SUBJECT: NRC INSPECTION REPORT 70-1113/2006-202 AND NOTICE OF VIOLATIONS

Report No.: 70-1113/2006-202

Global Nuclear Fuel - Americas, LLC Fuel Fabrication Facility NRC Inspection Report 70-1113/2006-202

Figure 1 Schematic of Reactor-Kiln

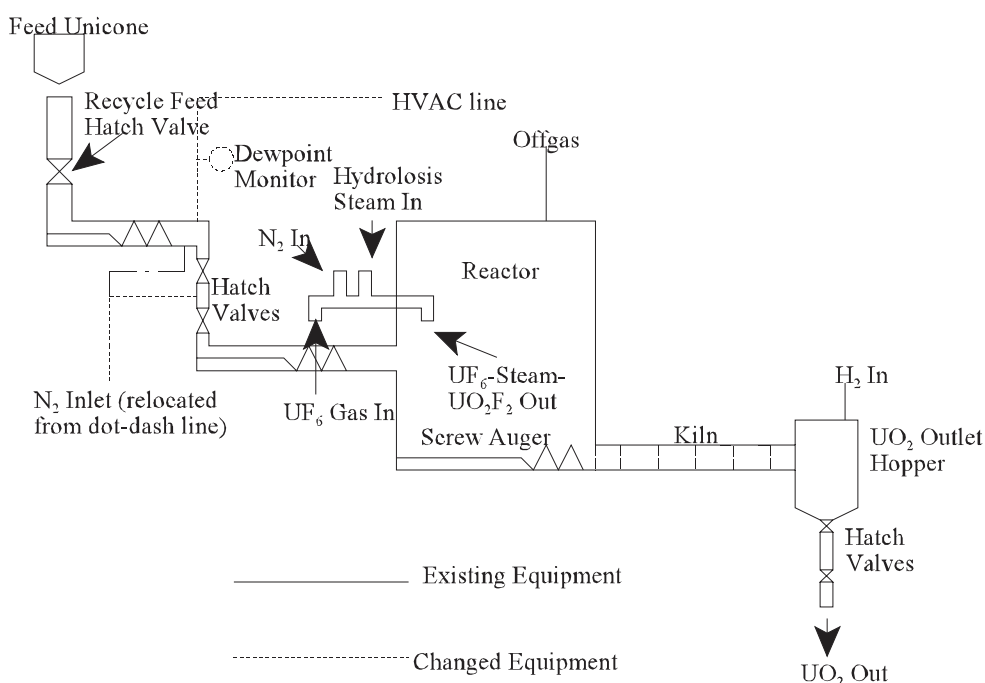
The inspectors reviewed several changes to the DCP Reactor-Kiln CSA made in response to a recent internal event. CSA 1332.01, Rev. 10, was issued to add a dewpoint moisture probe on the Heating, Ventilation, and Air Conditioning (HVAC) vent on the upper recycle screw feed for the reactor-kiln in Conversion Line 1 (Change Request 06.0174). At the same time, the pressure transmitter for the diatomic nitrogen (N₂) supply was relocated (Change Request 06.0231) so that pressure could be easily controlled (see Figure 1). The licensee stated that these changes were made following a recent event in which a unicone feeding the reactor-kiln was left attached and accumulated a small quantity (stated as ~1/2 cup) of liquid water. The licensee

determined that this occurred as a result of two leaking “hatch valves” on the reactor feed. The two valves comprise an air lock on the inlet side that is intended to maintain the appropriate atmosphere in the interior of the kiln and prevent backflow to the feed unicone. As a result of that event, the licensee determined that the failure of the hatch valves could lead to a previously unanalyzed backflow scenario. The inspectors determined that the event was not safety significant because the unicone must be essentially empty for backflow to occur, and the amount of uranium and moisture present was small. The inspectors determined that the moisture probe, upstream of the hatch valves, should provide for effective early warning of backflow.

The inspectors confirmed that functional test 1332-20 for the dewpoint monitor specified that the test must confirm that the recycle feed hatch valve closes when the moisture detection probe exceeds its setpoint. The licensee indicated that it performed the test by removing the probe and exposing it to ambient air, which contains enough moisture to actuate the interlock. The inspectors determined that the functional test was adequate in that it tested the entire system. The inspectors determined that the change was safe.
